Note to editor/reviewers. Plain text represents the original comment, and bold text represents the response.

Reviewer 1:

The paper presents a valuable exploration of the sources of error and potential improvements of common predictive methods for debris flow parameters. I have a few suggestions below:

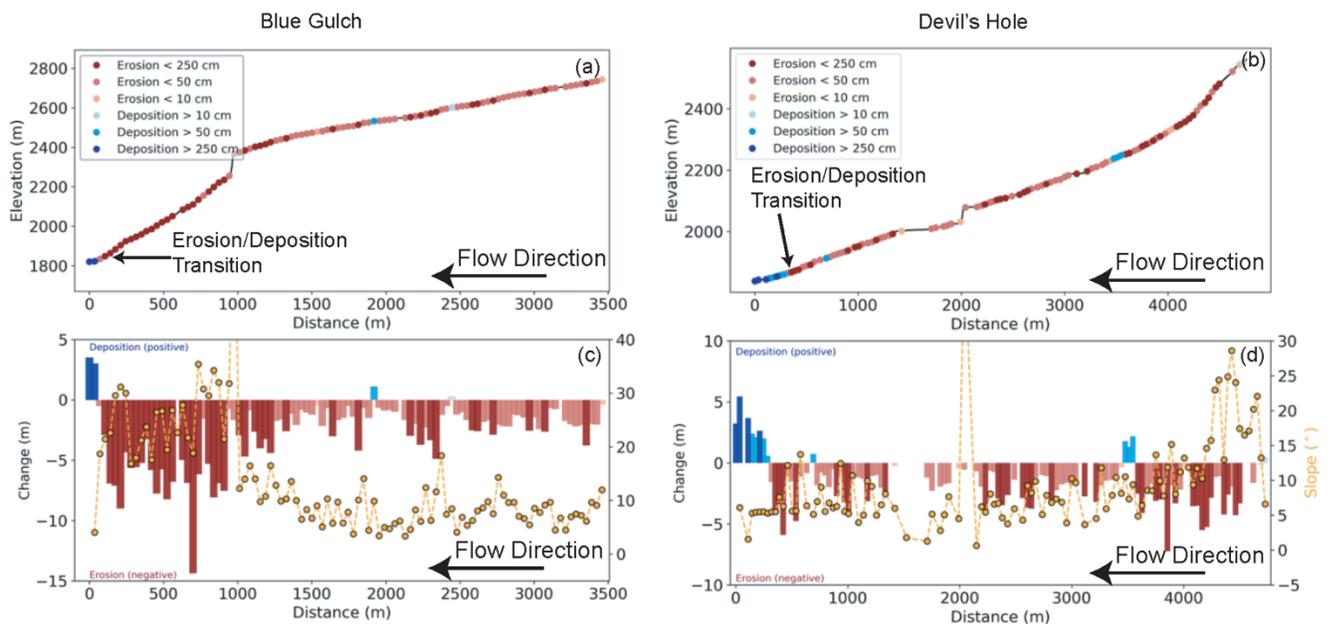
Figure 3 - isn't this backwards for (b)? Blue is deposition and red is erosion?

One thing that may be making this confusing is that I didn't indicate the flow direction. I have now done this on the figure. The colors in Figure 3b are correct. In figure 3b flow goes from ~4800 m to 0 m (this is the outlet), as flow moves from the upper reaches you see lots of erosion (red). There is a little bit of deposition (blue) at a low sloping spot around 3500 m, but the channel is mostly erosional (red) until the slope flattens out around 500 m. This can also be visualized in figure 3d. But in both cases the blue color is equal to deposition, and we are showing that as a positive value. We also added this text to make it more clear:

“Using the two lidar datasets (1 m pixel), we subtracted the elevation of the post event lidar from the pre event lidar ($Z_{2021} - Z_{2016}$) to create a DoD map of erosion and deposition throughout the Grizzly Creek burn area (Figure 2 and Figure 3).”

Based on that method readers should be able to see that wherever the post event data is positive, it should be equal to deposition, and those values are shown in blue in the legend.

New version of the figure is shown below.

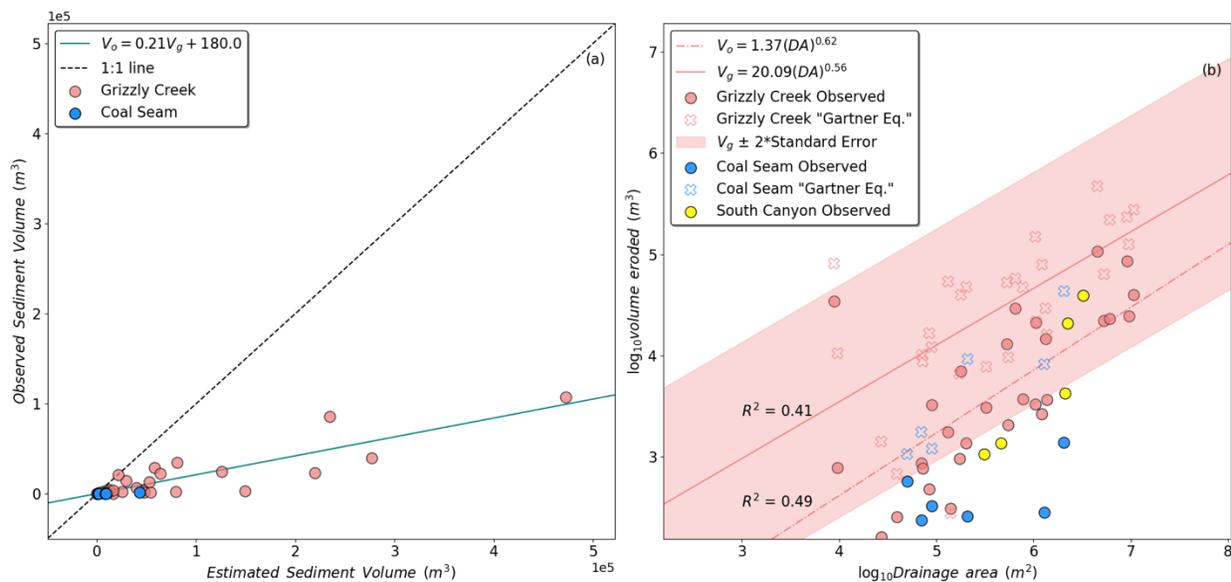
Section 3.3 - you might comment on the fact that you used data from rainfall gauges close to the measured debris flow events, whereas Gartner, et al, and M1 model relied on a more scattered network. In essence, they were forced to rely on widely spread input data while you have the advantage of comparing to local data. I would like to hear your thoughts on this difference. Clearly, it is better to you more local data, but what can you say about the need in other cases to rely on general data as in Gartner, et al.?

This leads to a bigger issue. The Gartner et al. and M1 models rely on a dataset with limited accuracy, but smoothed over an area and temporally. You are using more accurate data, which one would expect to produce better results, but in some ways compares apples to oranges. For instance, earlier volume prediction models relied on StatsGo or other generalized soil data for things like Liquid Limit. More accurate liquid limit measurements would not improve that model because they represent micro-data that is very different from the area-averaged data that the model used. The area-averaged data is not very good, but simply adding focused accurate data does not improve the roughness of the model. I want to make sure that your analysis does not fall in the same trap - providing more precision on a dataset that lacks in accuracy. I think it would help to comment on this disconnect.

Regarding the distance from a rain gage, the Gartner et al., 2014 paper uses gages that are within 2km of a watershed, and the Staley et al., 2017 paper uses gages that are within 4 km of a watershed. In this study, our gages are on average 4.2 km from the watersheds of interest, but we have a maximum distance of 6.8 km. I have amended the text to indicate this now:

“The maximum distance between an observation and its associated gauge was 6.8 km, the minimum distance was 0.2 km, and the average distance was 4.2 km (Rengers et al., 2023b). These distances are similar to other studies. Staley et al. (2016) used rain gauges within 4 km of an observation to generate the debris-flow inventory used to develop the M1 model, and Gartner et al. (2014) used distances of 2 km to assign storms to debris-flow activity.”

Figure S1. Map showing initiation locations of debris flows with respect to rain gauges and verified debris-flow deposits.

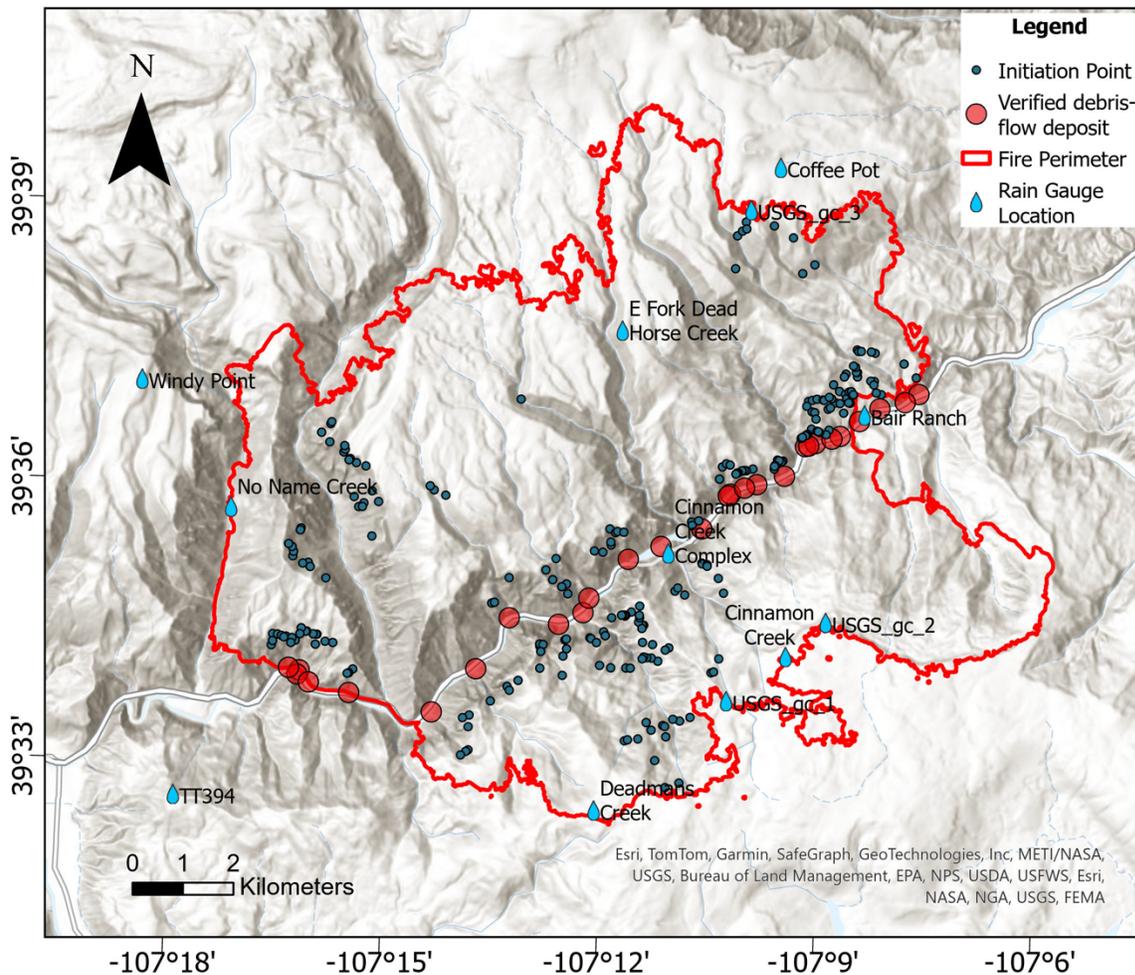
Line 195ff - even more important than the side of the canyon (north or south) and the proximity, is the elevation of the rain gauge, to account for orographic effects. Can you include a comment on this?

I agree that both elevation and the side of the canyon are important. Our mapping of debris-flow initiation showed that most of the debris flows started toward the canyon rim. In terms of elevation, this puts the initiation points closer to the elevation of the gauges, even if they are not as close distance-wise. Furthermore, due to the gage locations, we had to use the data available and didn't often have the luxury of choosing between both canyon side and gauge elevation. I made a map of the initiation points and the rain gauges that I have now added to the supplement.

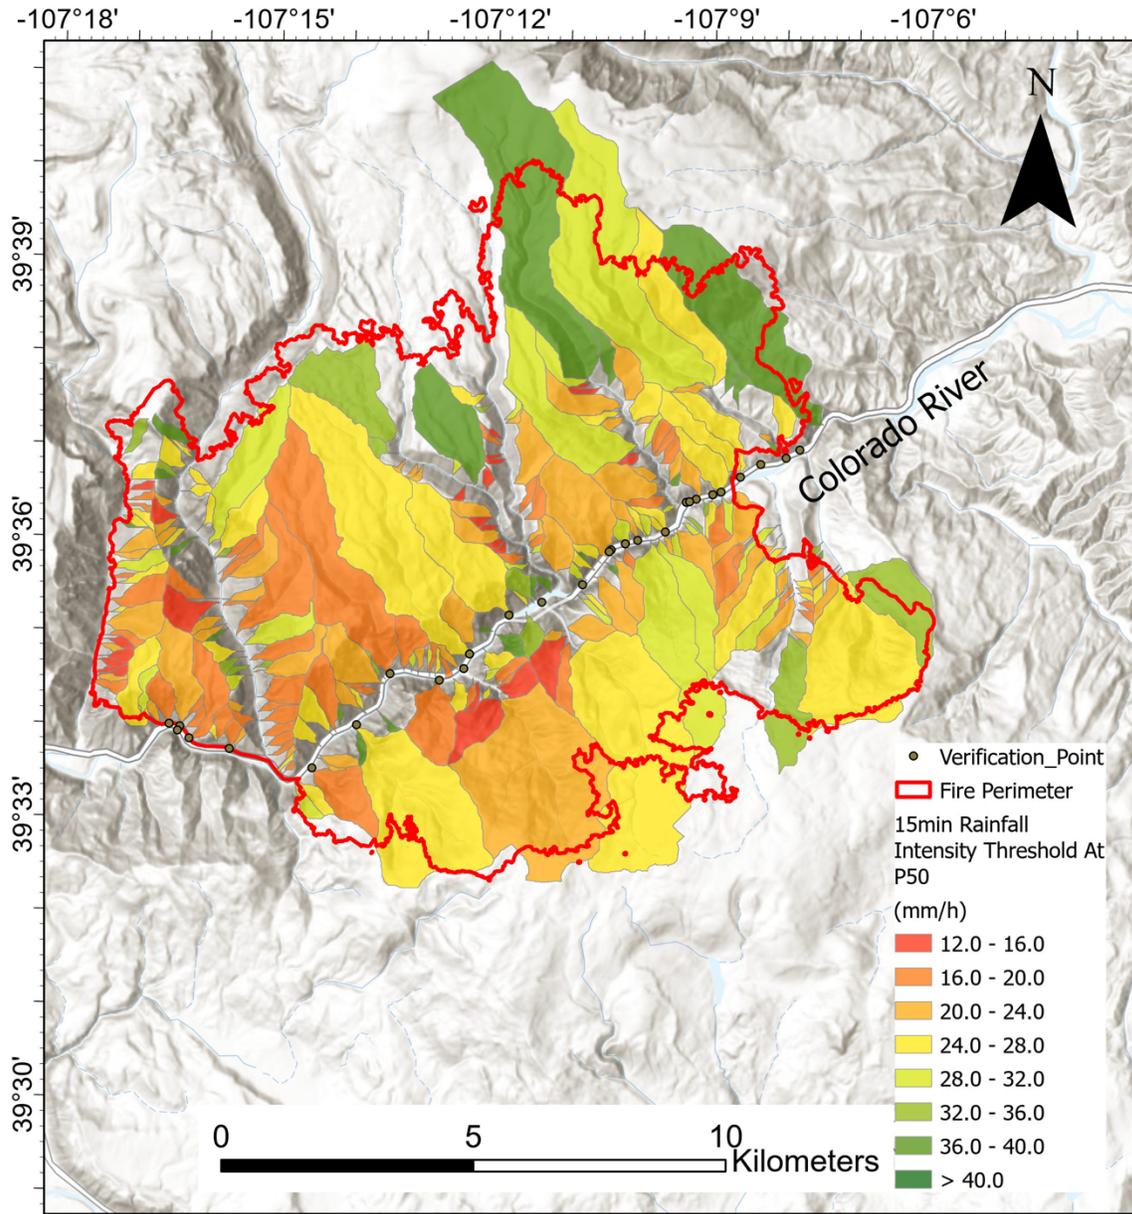
6. Figure 1: I would have found it helpful to see the locations of debris flows on this figure rather than on a separate figure.

Good Suggestion. I have now added the locations of the debris flow points to Figure 1. I didn't remove them from Figure 2, as I think they are useful reference points in both figures. I also changed what I was showing in Figure 1 to something more relevant. Instead of showing the likelihood for debris flow initiation given a 15-minute rainfall intensity of 24 mm/hr, I am now showing the 15 minute rainfall intensity threshold assuming a 50% likelihood of debris flow

initiation. The median value from all of these basins is used to estimate the Year 1 firewide threshold. I have also updated the caption to reflect this:

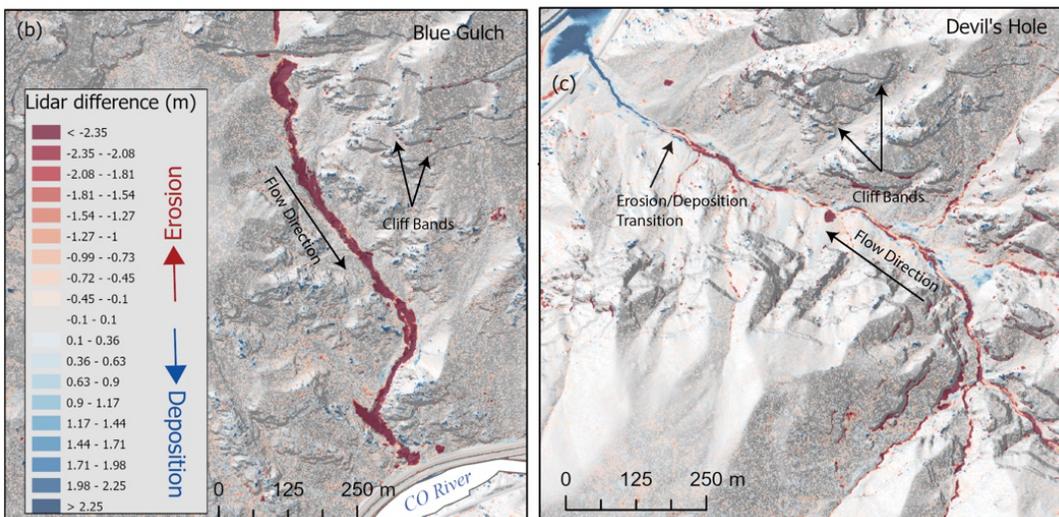
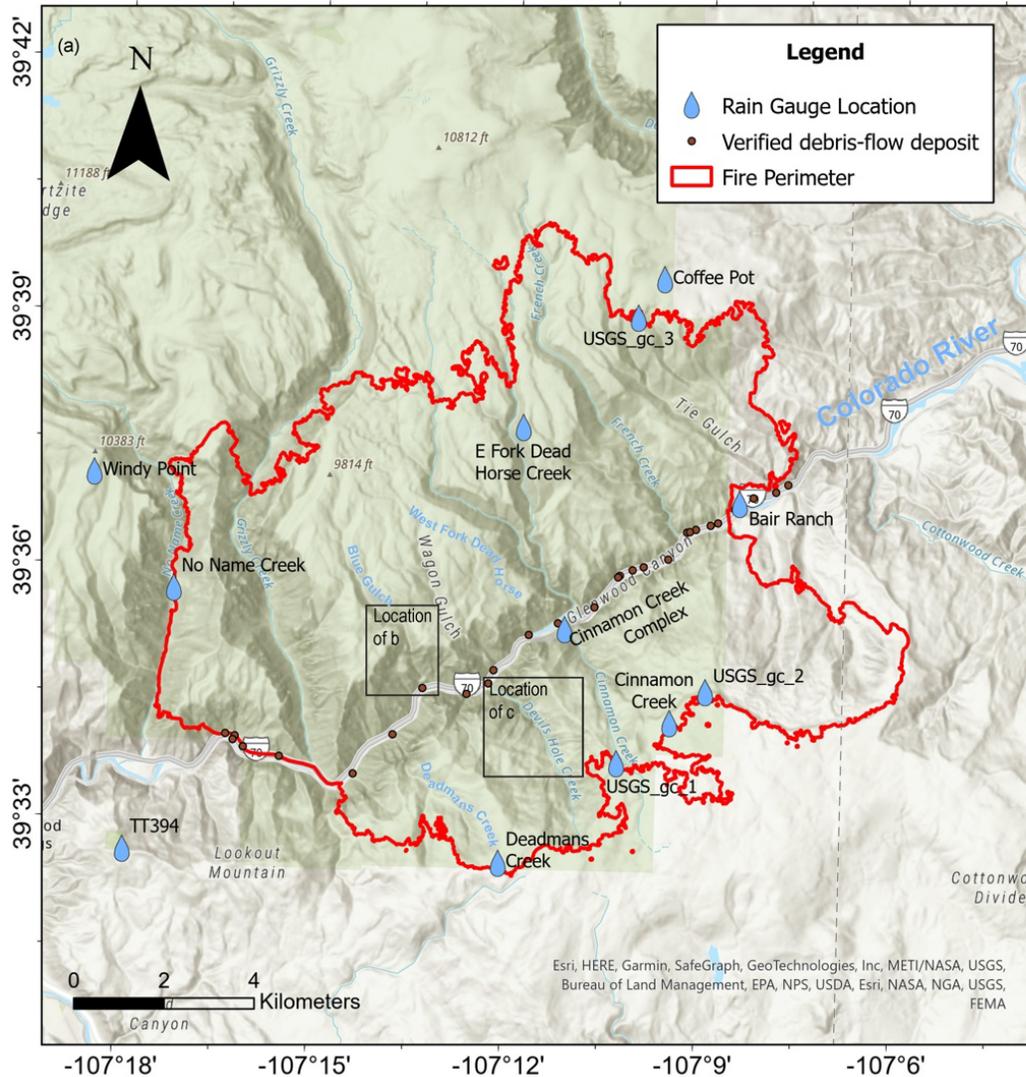
7. Figure 2b: I am not seeing deposition at the end of this debris flow track. For both b and c, consider adding an arrow to show flow direction.

I've now added an arrow to show flow direction on Figure2b and 2c. As far as not seeing the deposition, this is a little hard it shows up more clearly in Figure 3. For the reviewer, I have illustrated this below. There is a small blue spot to the right of the red erosion. I've zoomed in

and I added a black circle to indicate the deposition location for the reviewer. For the readers of the paper, I think they can see this most clearly in Figure 3a and 3c.

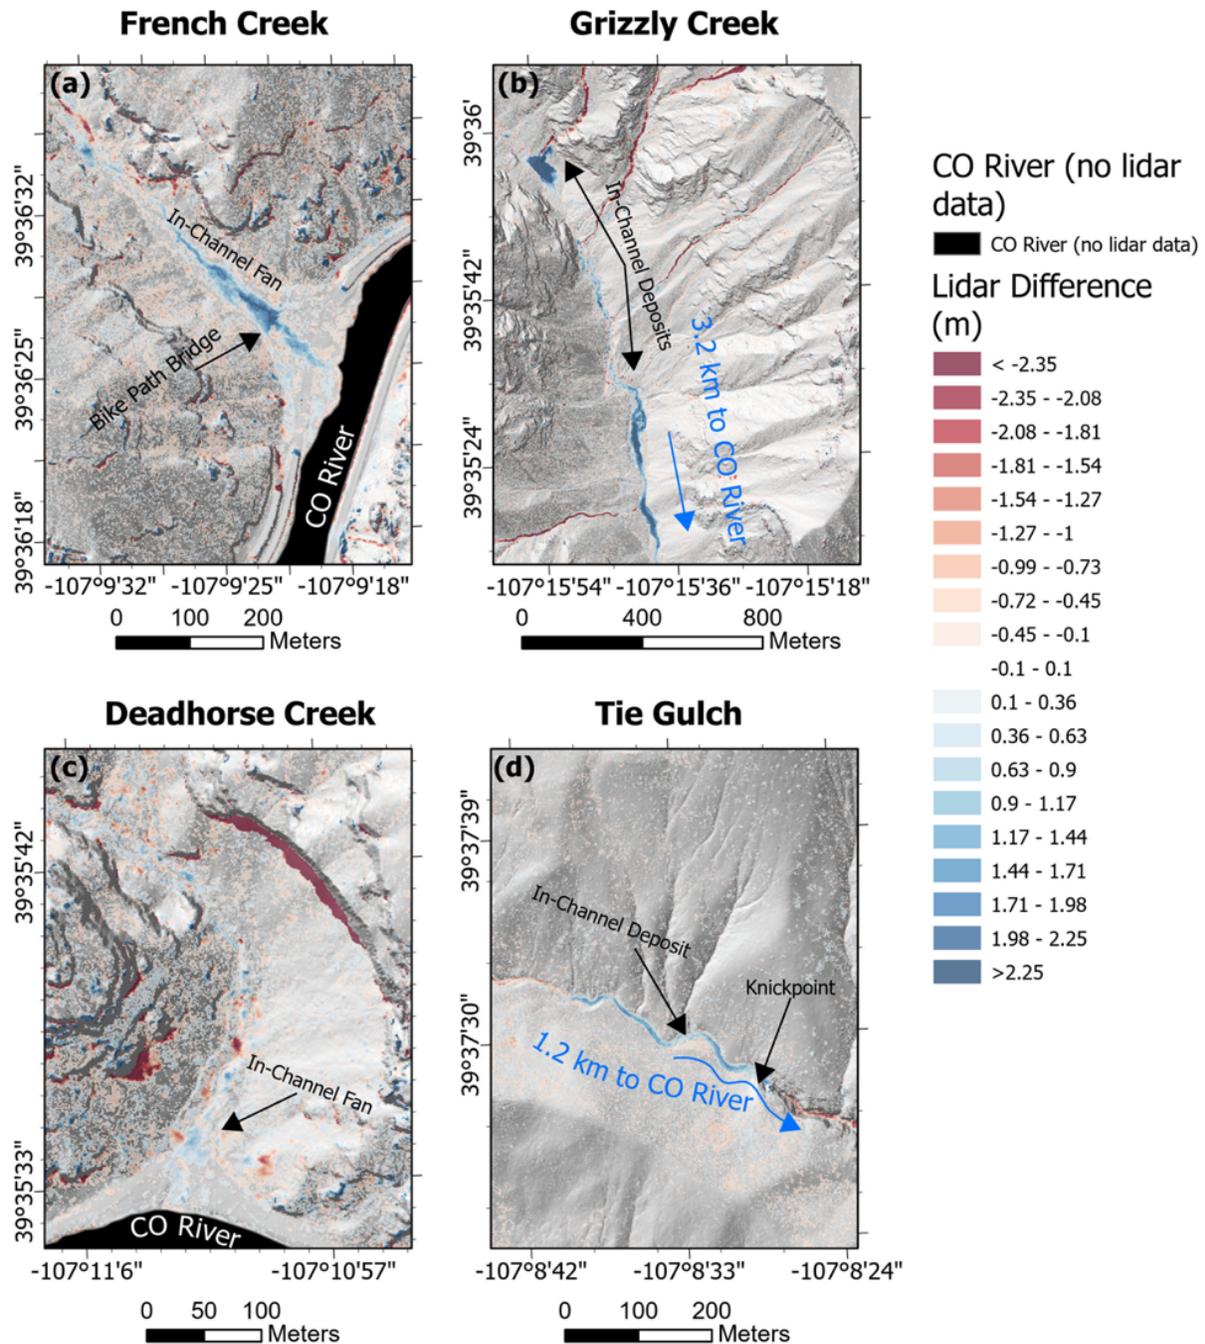
8. Figure 5d: this doesn't look like a fan - just in-channel deposition?

Good point. I have changed the figure to say “in-channel deposits” and adjusted the text throughout.

Figure S6. Comparison of all the erosional volumes in locations where we have known depositional volumes. Error bars represent the uncertainty. Note that many channels contributed to an in-channel deposit in Grizzly Creek, but

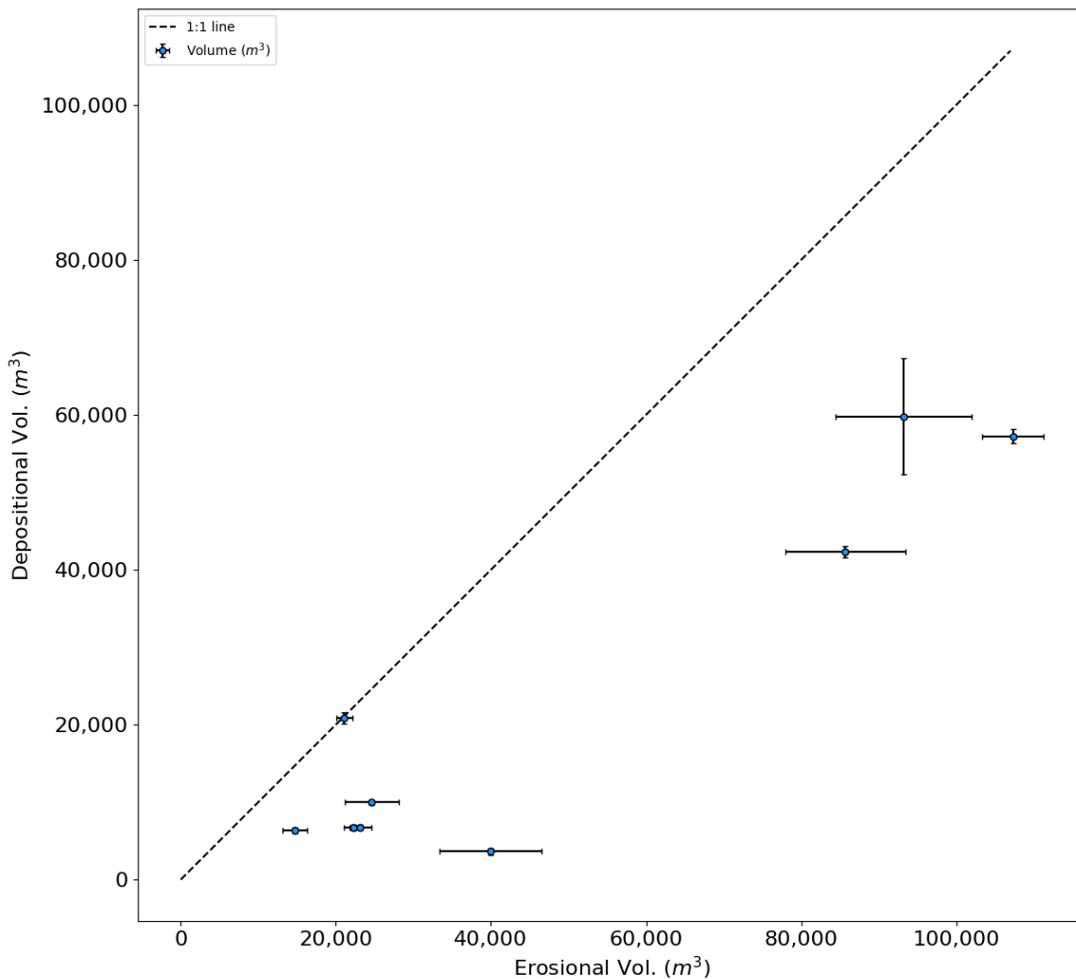
9. Figure 7: this is a nice figure but kind of a lot to take in. I am curious about how the erosion and deposition volumes compare at sites where both of those measurements were collected, but it's hard to evaluate that in this figure - could erosion-deposition comparison be pulled out as a separate figure or subplot? Then just show erosion in this plot? Do each of the debris flow volume points correspond with a rain intensity point in the bottom graph? Could be useful to have a volume vs. intensity plot, as an alternate way to visualize the data.

This is a really useful comment. Based on this comment I have created a new figure that I have added to the supplement to show erosion versus deposition, and I've added in the uncertainty in both erosion and deposition. I will add this in as a new supplemental figure. Here's a note to the reviewer that I will put in the caption. Many channels contributed to an in-channel deposit in Grizzly Creek, but for the purposes of comparing erosion and deposition, all of the erosional channels contributing upstream of the deposit were summed to compare with the deposit volume.

As for updating figure 7. I don't think it hurts to leave in the deposition. I like the suggestion about plotting erosion versus rainfall intensity, but I think it is misleading so I am not including this figure. Here's the problem. There were multiple rainstorms between the two lidar datasets. We know the timing of the debris flows, as we have highlighted in several figures, and for comparison with the Gartner Volume equation we use the peak 15-minute intensity or sum of peak 15-minute intensities in the case of multiple debris flows because that is consistent with their methodology. However, because there were multiple storms and in some cases multiple debris flows, a plot of erosion versus maximum rainfall intensity may not account for the multiple pulses of the erosion that took place due to the cumulative rainfall and therefore it may be misleading.
